NUCLEAR REGULATORY COMMISSION

Title: Advisory Committee on Reactor Safeguards
ESP Ad Hoc Subcommittee Meeting

Date: Wednesday, March 2, 2005

SSE vs RG 1.60

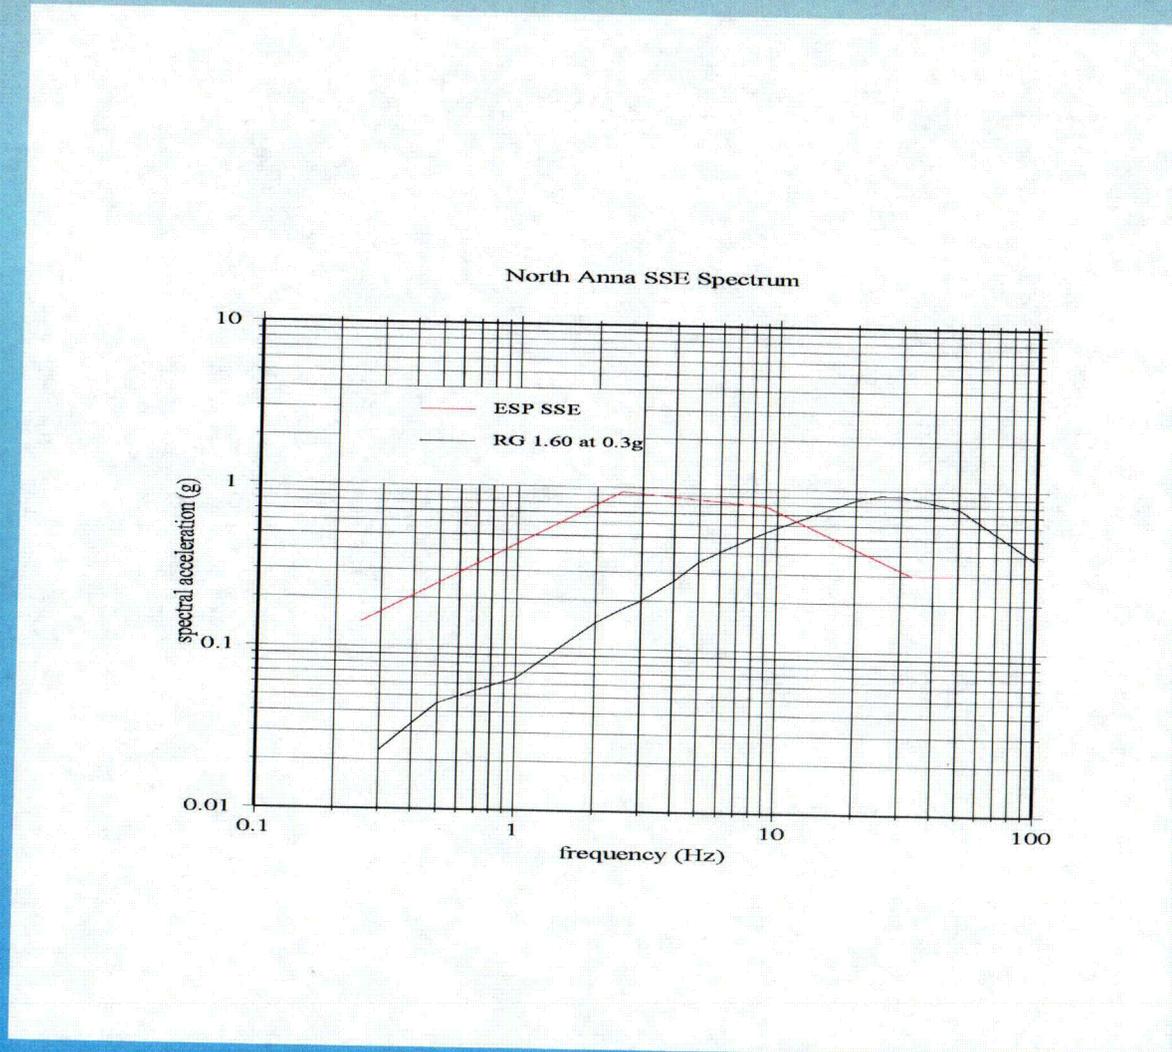
18 DR. APOSTOLAKIS: So how does this figure
19 -- how am I to read this figure? I mean the
20 independent variable is the frequency? So that if I
21 go in with a frequency of 10 hertz --

17 DR. APOSTOLAKIS: I'm still trying to
18 understand how to interpret the figure.

- Because North Anna is a rock site, site SSE exceeds design SSE at high frequencies for designs certified to date
- COL applicant would need to resolve disparity if one exists (dependent on design selected)
- See SSE vs. RG 1.60 diagram

8 Dominion chose to use an SSE spectrum that
9 falls on top of their performance-based spectrum. The
10 staff accepts or plans to accept that based on the
11 fact that it is conservative with respect to the 5
12 times 10 to the minus 5th low and high frequency
13 curves.

22 MR. MUNSON: If you look at the frequency,
23 you consider that as the natural frequencies of
24 different systems, structures in a nuclear power
25 plant. So our resident frequency say of 5 hertz
